**SERVICE  
BULLETIN  
417  
4 CYCLE**

**ISSUED:** October 11, 2002  
**SUBJECT:** Fuel Line Routing

**Dates Affected:** June 24, 2002 to September 25, 2002  
**Date of Manufacture (DOM):** 02175C - 02268C  
**PLANT CODE:** C

Figure 3

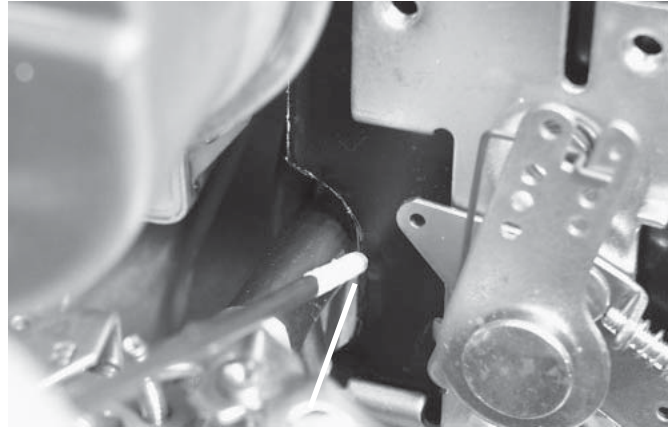
1. To determine if repair is required, inspect the fuel line routing. A gauge will be used to aid in this determination. To make a gauge use a piece of 1/8" round stock rigid material approximately 12" long. Make sure there are no sharp edges or burrs on the ends of the gauge.
2. The gauge will be used as a go/no-go gauge that can be inserted into the opening (fig. 2) between the muffler and the carburetor heater box down to the fuel line.
3. Using a light that can be focused in a concentrated area (such as a mag light), look between the muffler and the heat shield at the 1/2" O.D. black fuel line, see (fig. 2 & 3).
4. Check for clearance between the recoil housing and the fuel line where the fuel line passes through the blower housing on the carburetor side of the engine. If the gauge fits between the blower housing and the fuel line, the routing of the fuel line is good (fig. 3).

**GOOD**  
(1/8" PLUS CLEARANCE)

Figure 4

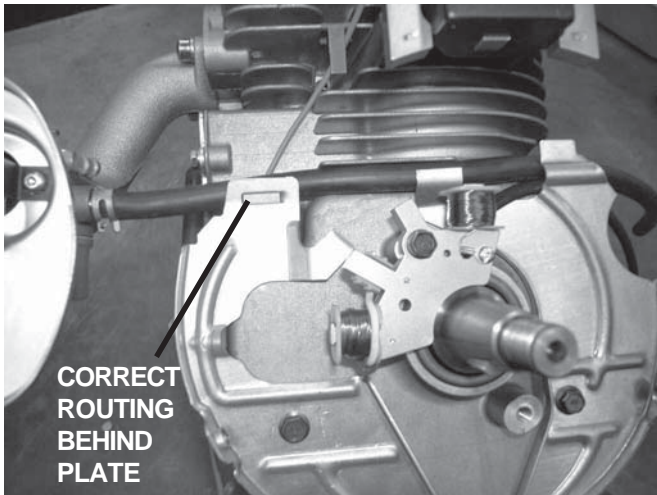
5. If the gauge does NOT fit between the hose and the housing (fig. 4) refer to rework instructions.
6. If the fuel line routing is deemed good, both the box (if applicable) and engine need to be identified as having been inspected. The fuel line gets marked with yellow paint marker dots as seen in (fig. 6). The product's box must be marked with a large magic marker by placing an "X" directly below the product identification label.
7. If the fuel line is routed properly, file an OPEESA warranty claim form with Tecumseh for 15 minutes labor, **referencing Service Bulletin # 417**. The dealer will be allotted a one time \$35.00 trip charge per retail location. Batch claim filing will be acceptable when performing multiple repairs. If you choose this option, it is **CRITICAL** that you attach a separate page to your claim listing ALL models, specifications and DOM numbers repaired.

**BAD**  
(LESS THAN 1/8" OR NO CLEARANCE)

1. Remove the carburetor / heater box cover assembly exposing the carburetor and the fuel line.
2. Remove the recoil / blower housing assembly.
3. Replace the fuel line using Part Number 30962. Cut the new fuel line to match the length of the fuel line removed. Install the new fuel line as shown in (fig. 5).
